Fire fighting alarm in Gardner/Snyder Thermal Power Station is centralized at S-1 & S-2 central control room, however, almost all the alarm are defective.

2) Malaya Thermal Power Plant

Fig. 5M-32 CONDITION OF PLUGGED CONDENSER TUBES FOR M-1

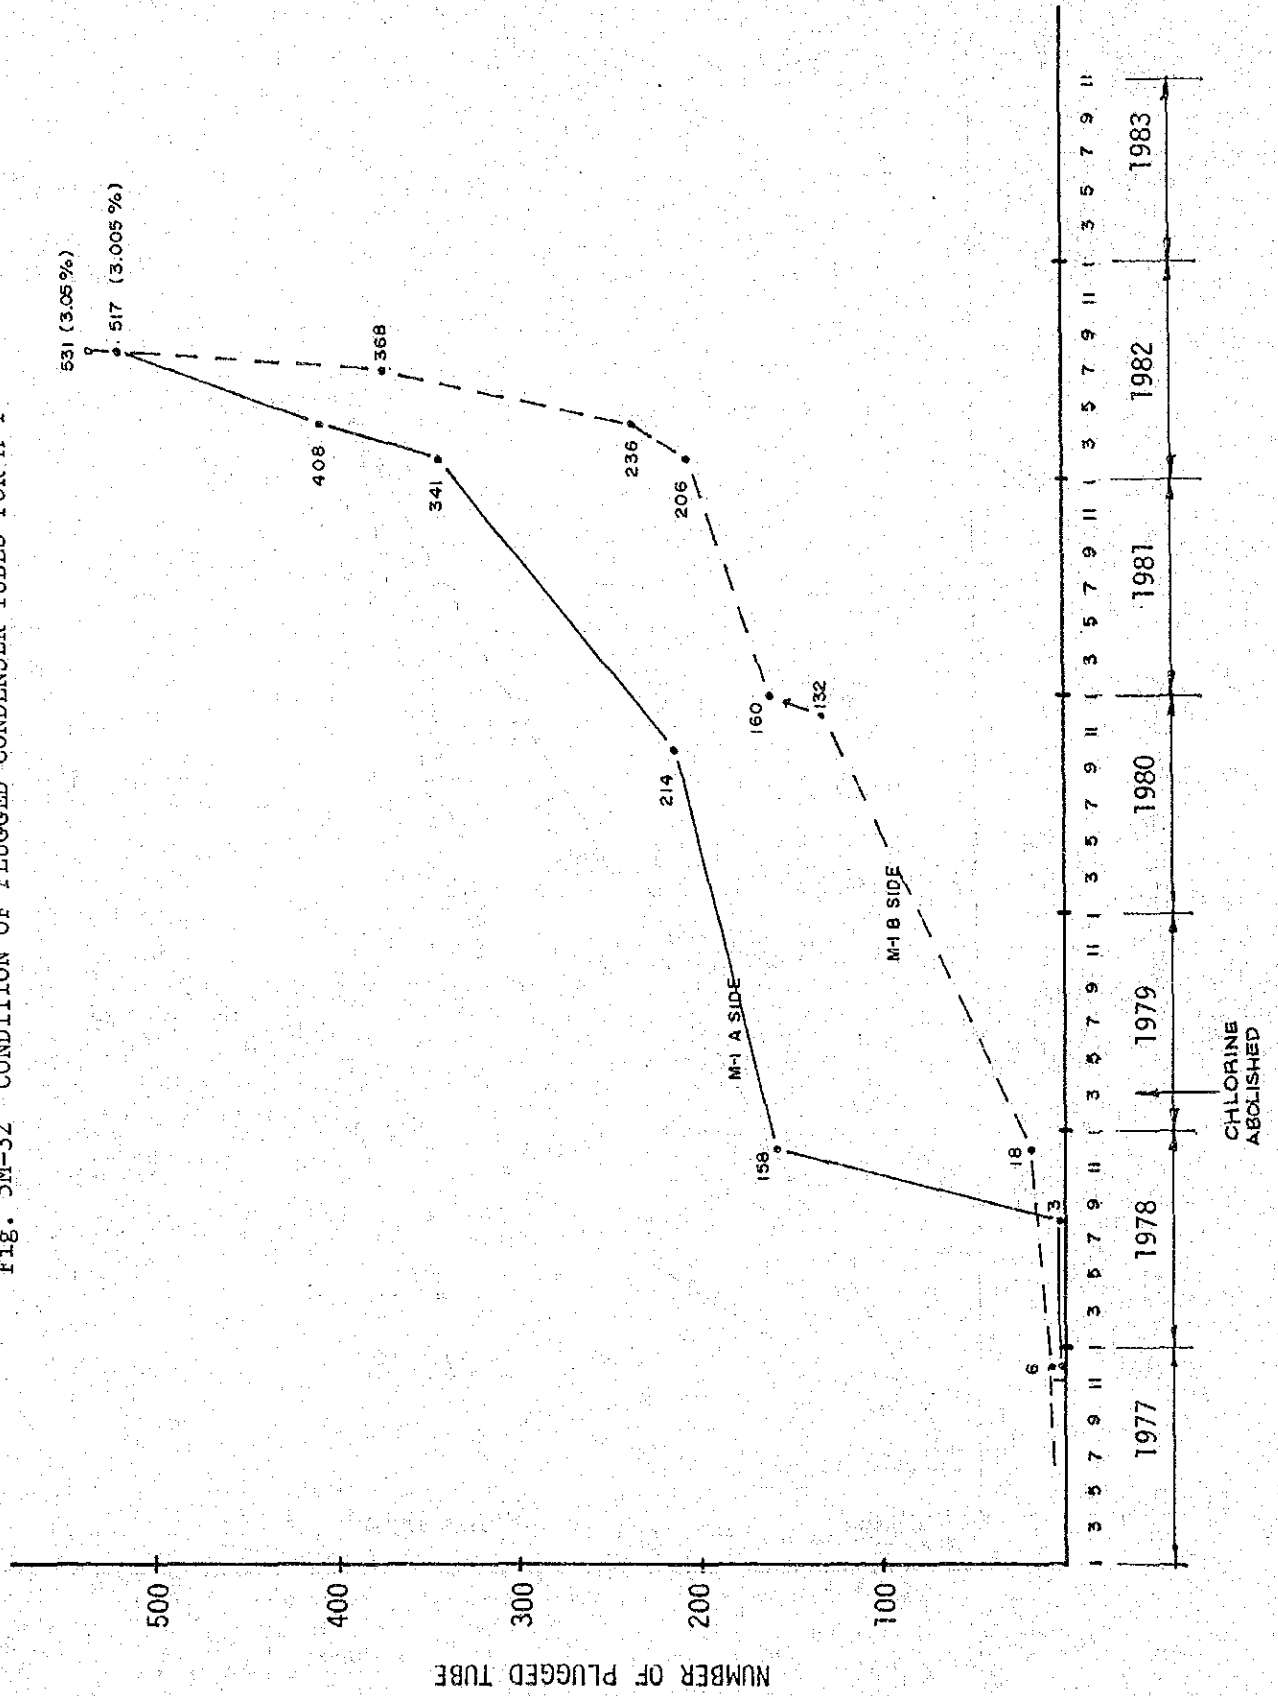
Evaluation of the analysis showed that the number of plugged condenser tubes are few, however, M-1 will encounter a big problem in the near future as shown in Figure 5M-32.

- (ii) As of August, 1982, the B side condenser tubes experienced plugging four (4) times since its commercial operation. In February, 1982, a total of 133 tubes (1.32%) were plugged. However, in June, 1982, a total of 1229 tubes (12.19%) were plugged.

Fig. 5M-33 CONDITION OF CONDENSER TUBES FOR M-2

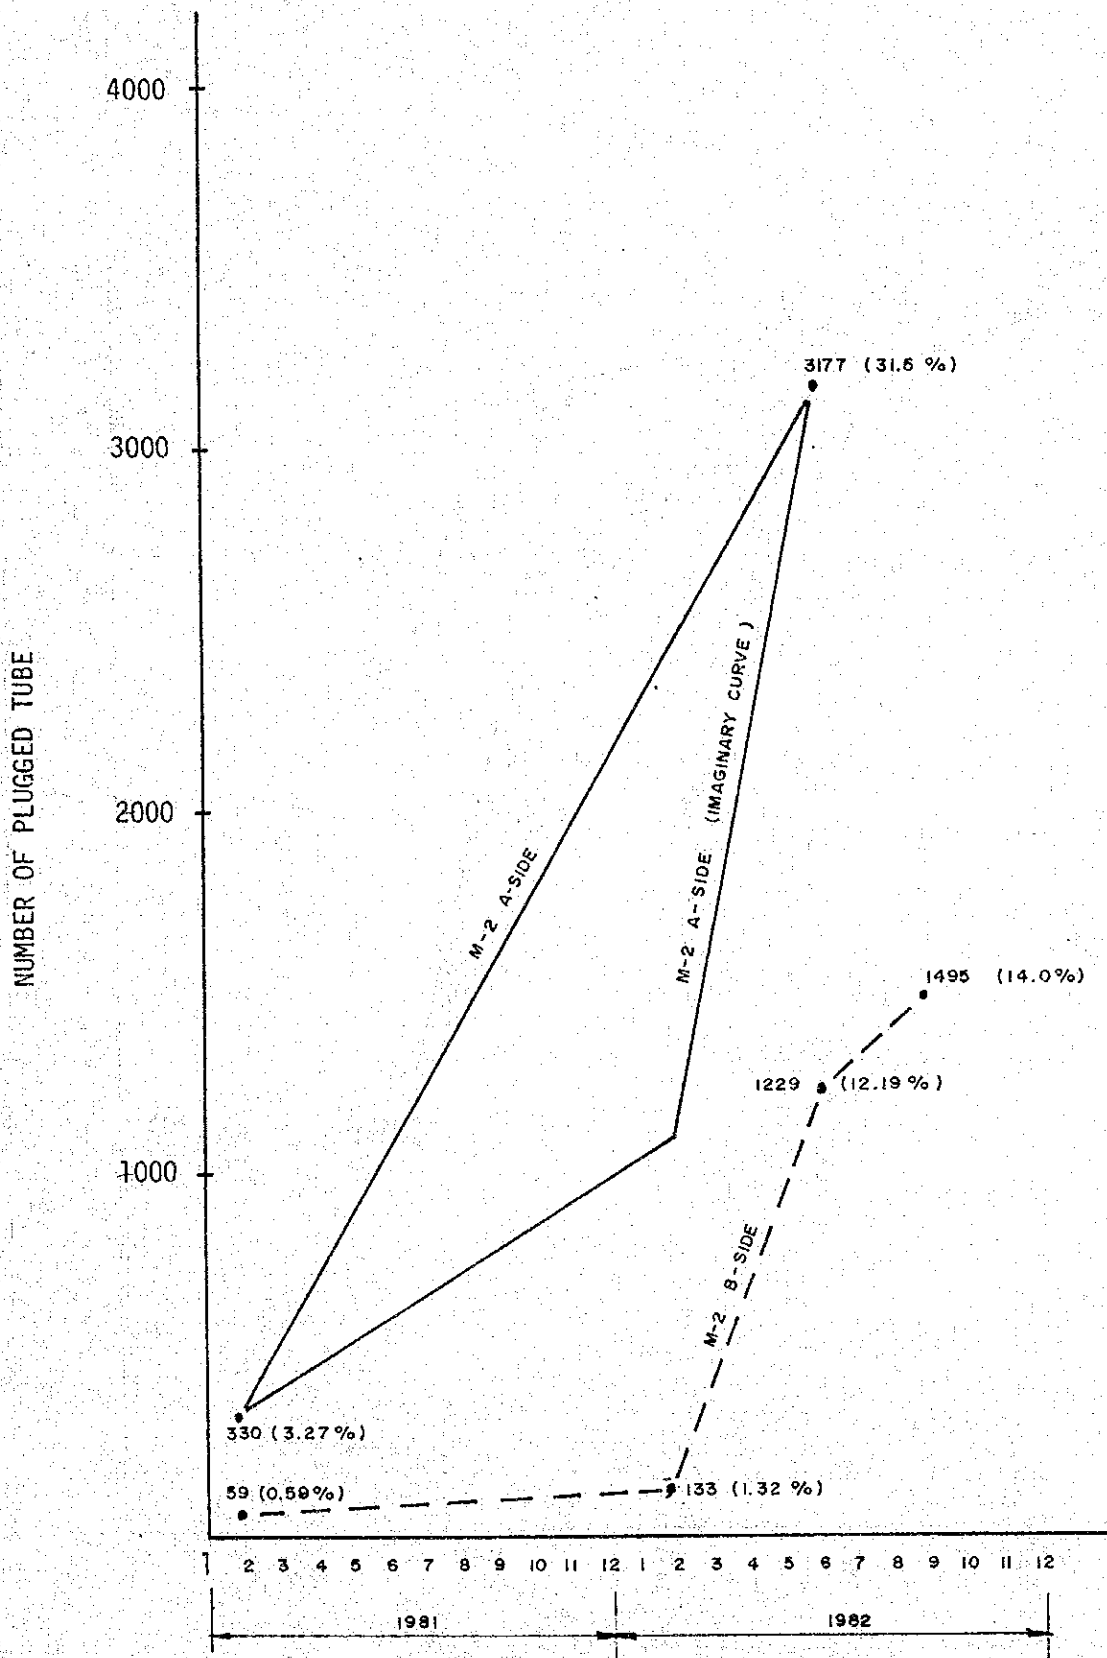
(iii) The rate of plugged tubes on the B side has abruptly increased between February and June, 1982. This means that M-2 has an alarming condition now.

We will presume that M-2 will encounter a big problem in the near future due to condenser tube leakage as shown in Figure 5M-33. To this problem, NAPOCOR planned to re-tube all condenser tubes to aluminum alloy tubes.

JICA team would like to recommend that planning of a preventive maintenance for the new tubes to be carried out.

Fig. 5M-34 FERROUS-SULFATE INJECTION SCHEME FOR M-1

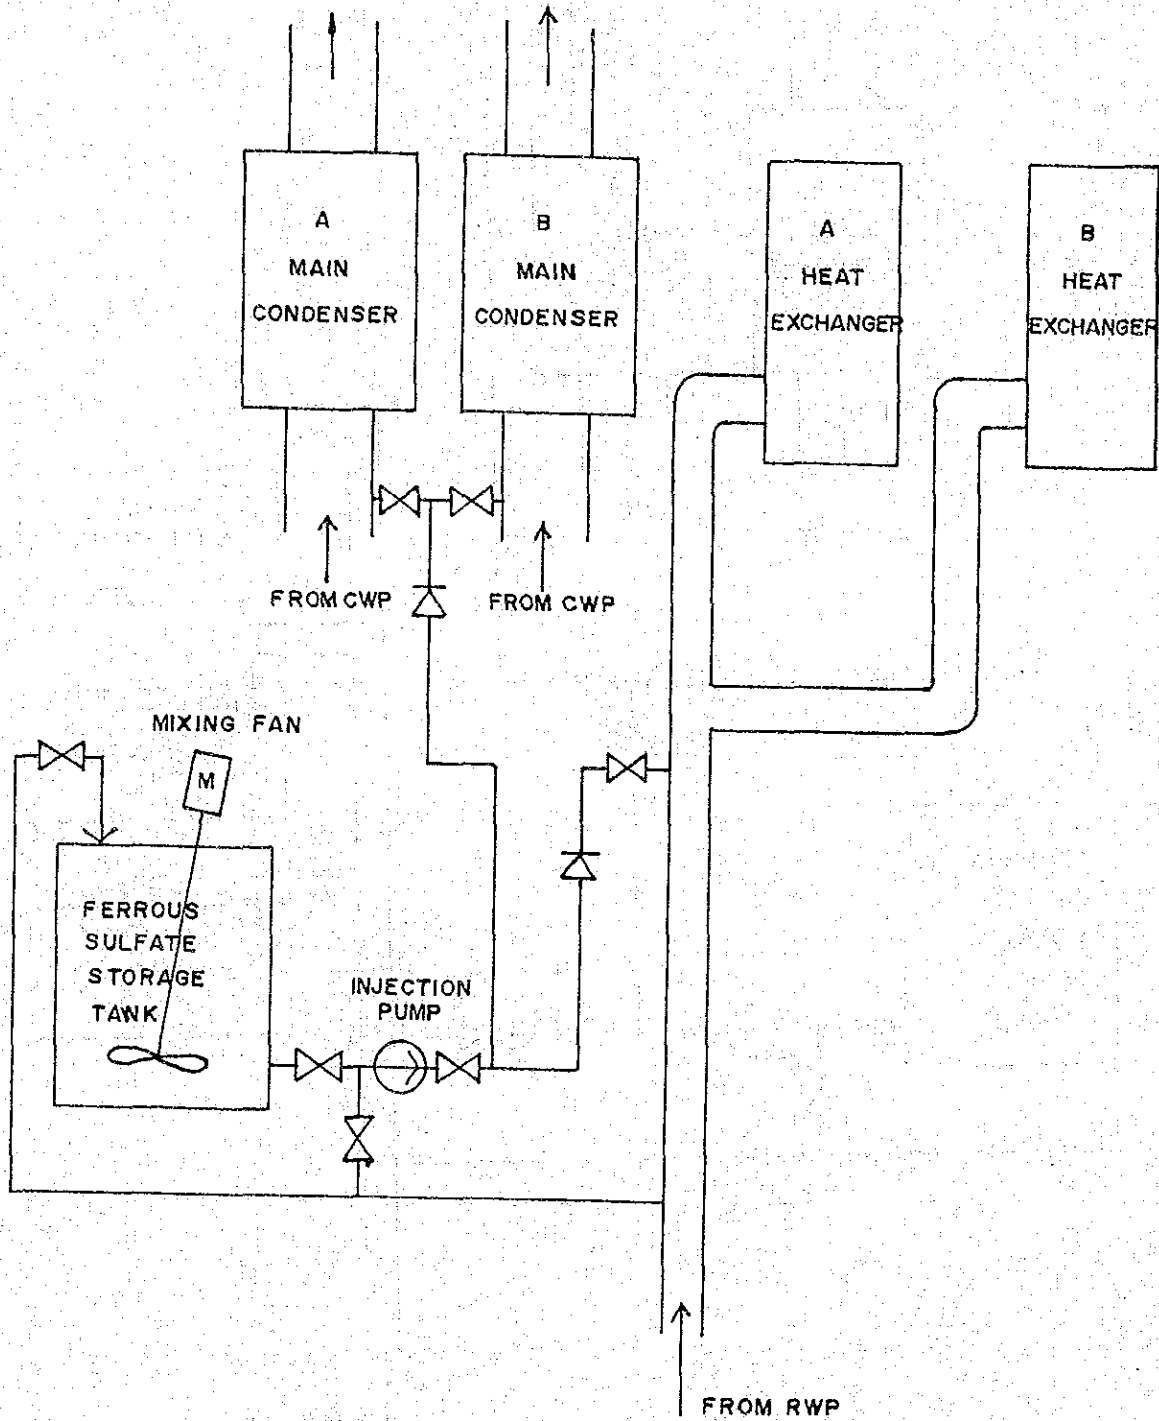
Herewith is the proposed ferrous-sulfate injection scheme:

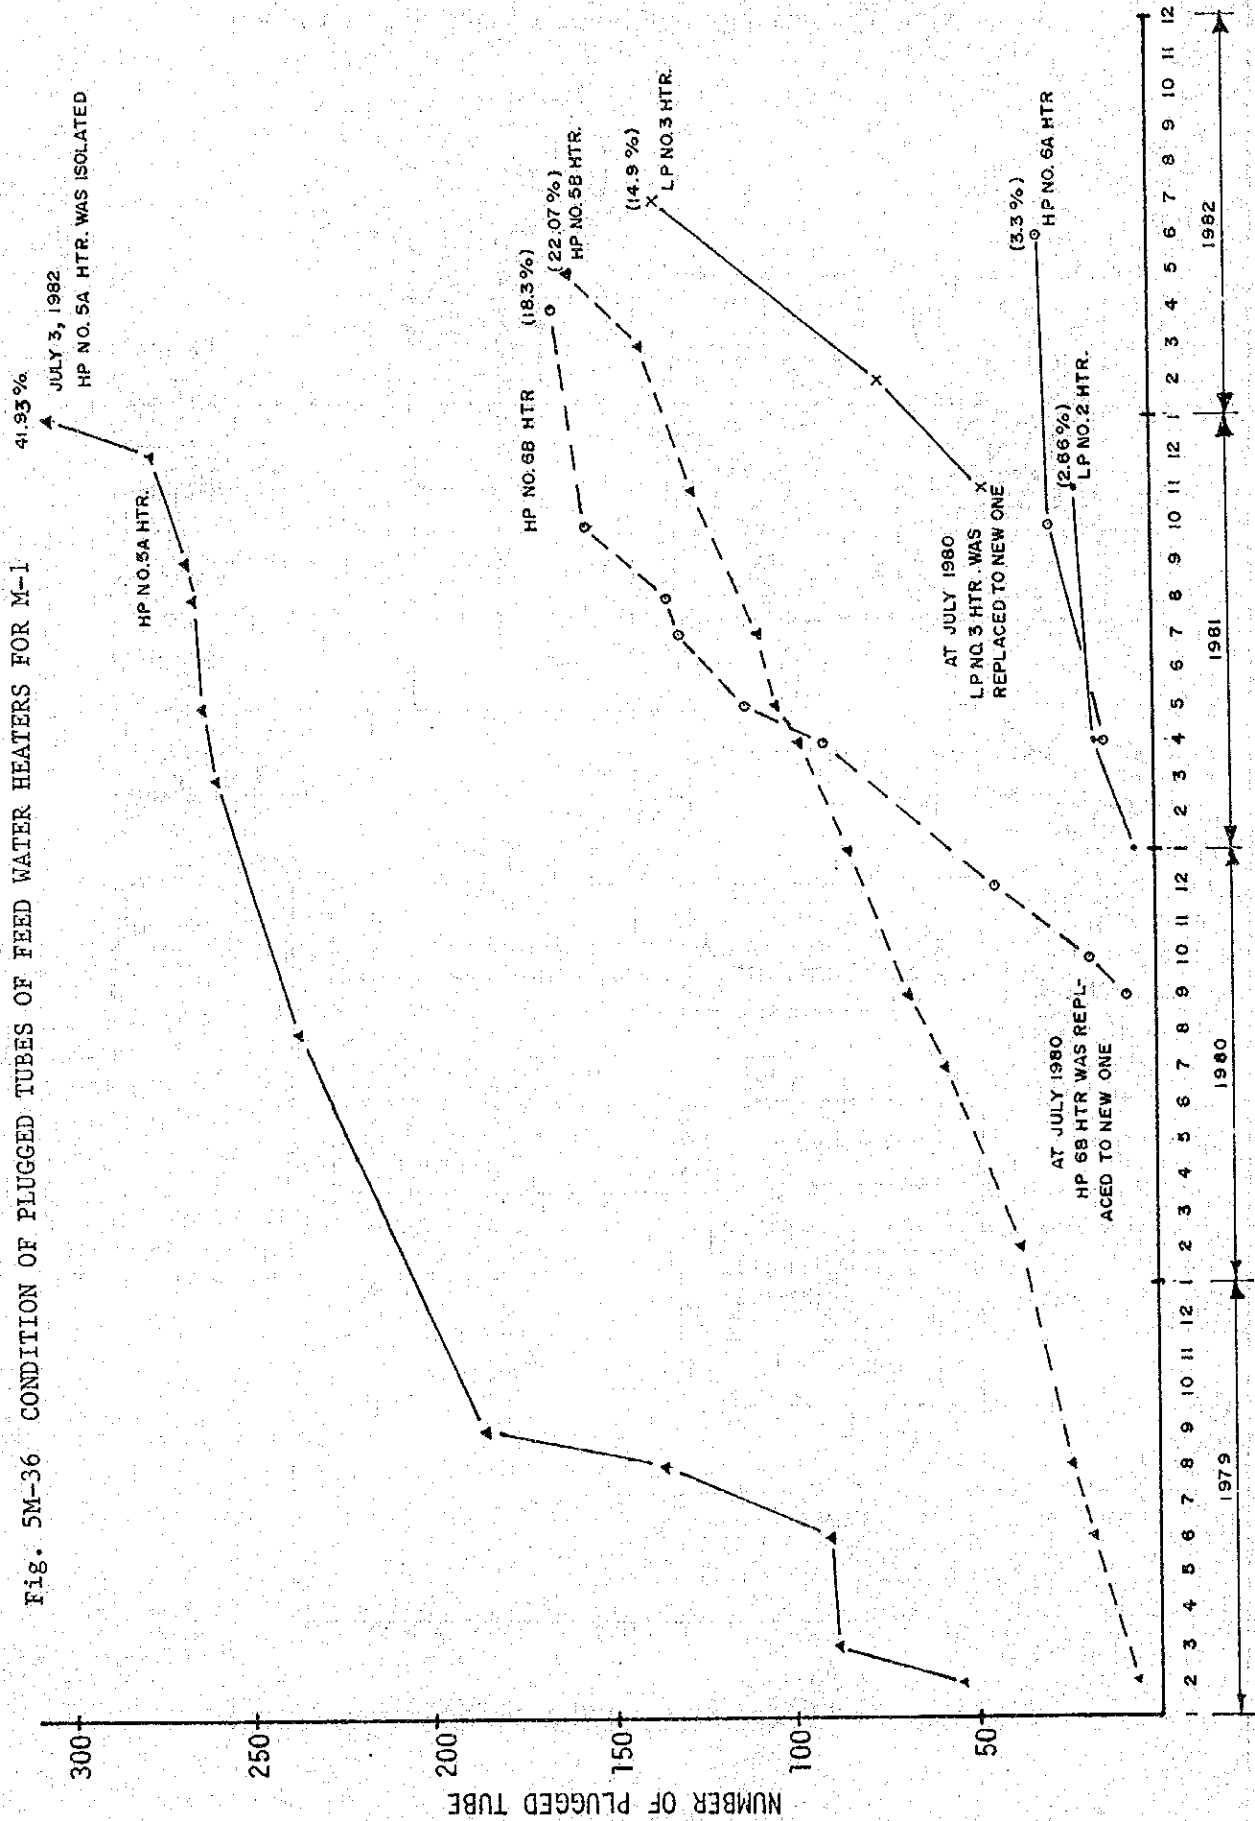
JICA team conducted a thorough study of the feedwater heaters of Malaya-1 concerning tube leakage. The result of the study is shown on Figure 5M-36.

HPH #5A has an alarmingly high rate of tube failure which accelerated between February and September of 1979. After this period, the rate of tube failure has decreased between September 1979 and Dec. 1981. However, the frequency has increased such that the percentage of plugged tubes went to a high 41.92% as of January 1982. By July, 1982 the feedwater heater was completely isolated from the system.
